Technical Bulletin

PRODUCT(S)
AFFECTED: **Integrity**

SUBJECT: Wiring Update Kit #609157 Now Available.

Fig. 2

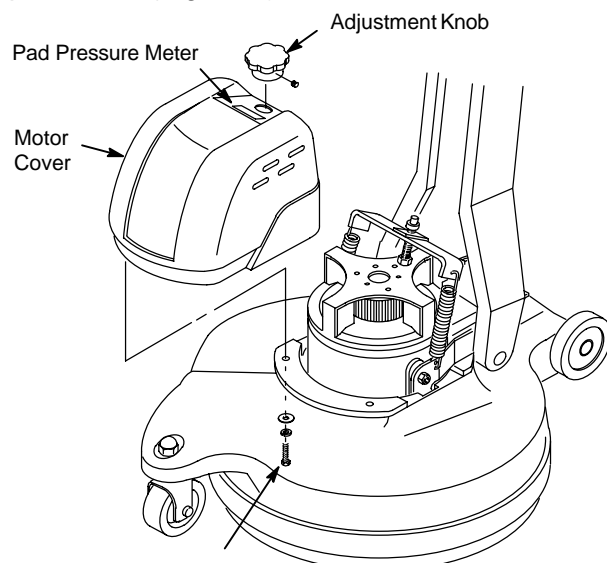
1. Unplug machine's power cord from wall outlet.
2. Remove panel from handle to access internal wiring (Figure 1).
3. Replace wire as indicated with new 7.5 inch black wire assembly. Replace handle panel (Figure 1).
4. Lay machine on floor and remove pad driver.
5. Remove motor cover by removing adjustment knob and four motor cover mounting screws from underside of machine (Figure 2).
6. Remove wires that are connected to pad pressure meter and replace them with new wire assemblies as shown (Figure 3).
7. Replace motor cover, adjustment knob and pad driver (Figure 2).
